Shoalhaven Ethanol Plant Upgrade PHA

**Response to Department of Planning Comments
Concerning Hazards**

**GHD Pty Ltd
October 2008**

**Shoalhaven Ethanol Plant Upgrade PHA
Response to DoP Comments**

TITLE: Stage V Molecular Sieve Sheet 1

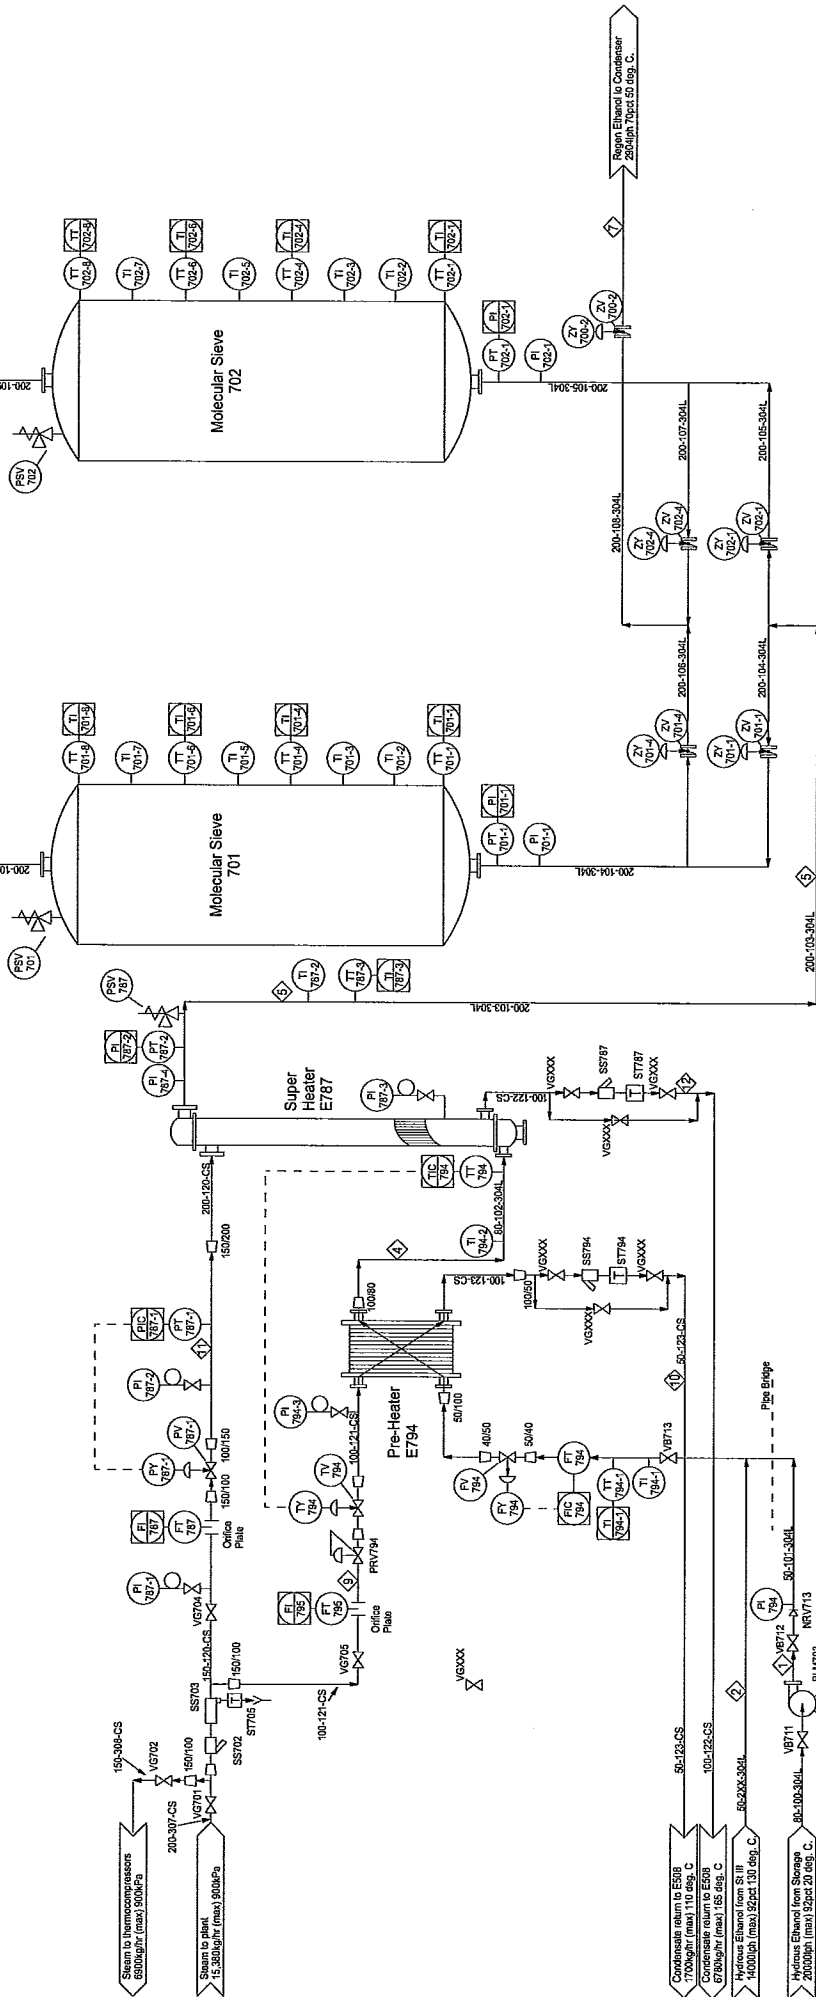
- 2. Clause 3.3.1(PHA) refers to the addition of one set(2 sieve units per set) of molecular sieves and superheater to bring the total to 4 sets. Process/plant description is required to identify the 6 vessels, 6 heat exchangers and 1 pump used under E3 in table D1. A process/plant description with P&IDs or process flow diagram should be provided to support the numbers used in table D1 for all equipment items. Please state the total sets of sieves that will be operational after this upgrade.**

- » Typically 3 mol sieves will be used but possible to use all 4 mol sieves. The QRA was completed for 4 mol sieves in operation.
- » Process description of mol sieve attached.
- » P&ID of a typical mol sieve is attached.

Figure 8-1 Individual Fatality Risk

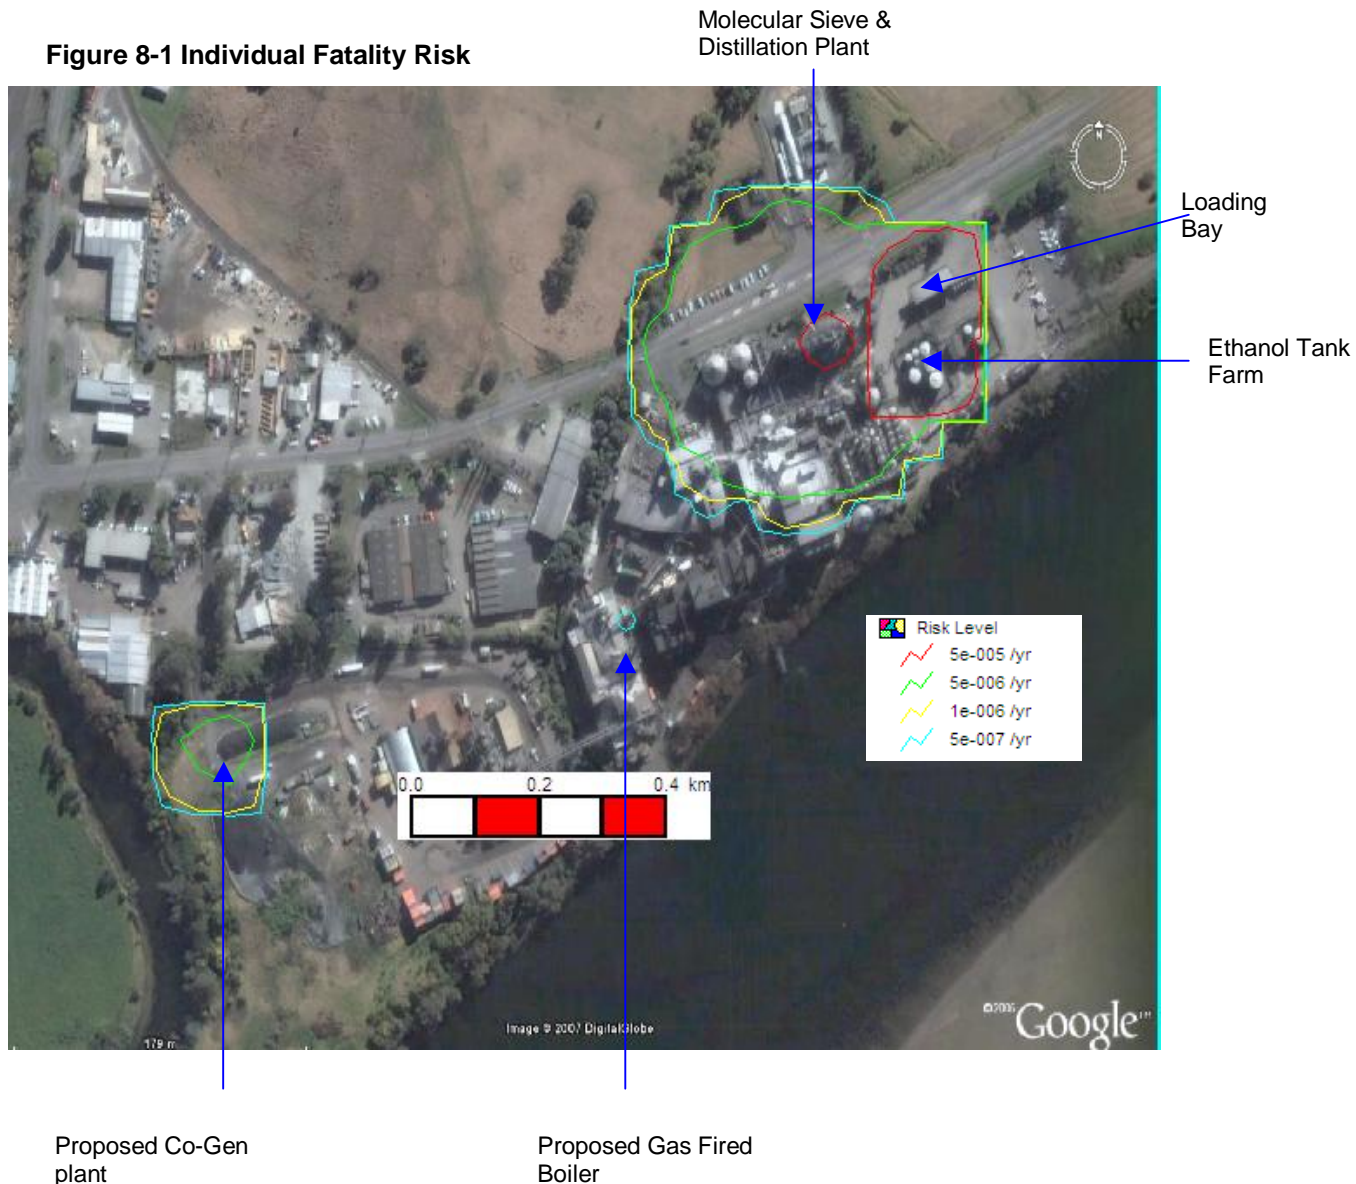
- 5. The PHA shows the risk contours. Please provide an assessment to demonstrate that the impact of the proposed activity on the existing site risk levels will not significantly increase the risks from the site and that the NSW published criteria are not exceeded.**

Figure 8-1 on page 29 shows the risk profile of the existing operation and the proposed changes with respect to ethanol production, ethanol storage and gas plants. The hazardous scenario not included in the model is the explosion overpressure from the dust (flour) cloud explosion. A PHA was completed for the flour mill and the storage facility in 2007 and was assessed as unlikely to cause an off site impact from dust cloud explosion.

There is potential for escalation from the dust cloud explosion but the flour storage and other solids handling are sufficiently separated from the ethanol plant and ethanol storage area. The dust cloud explosion is not expected to increase the risk profile (specifically the individual fatality risk of 50×10^{-6} pa) beyond the site boundary.
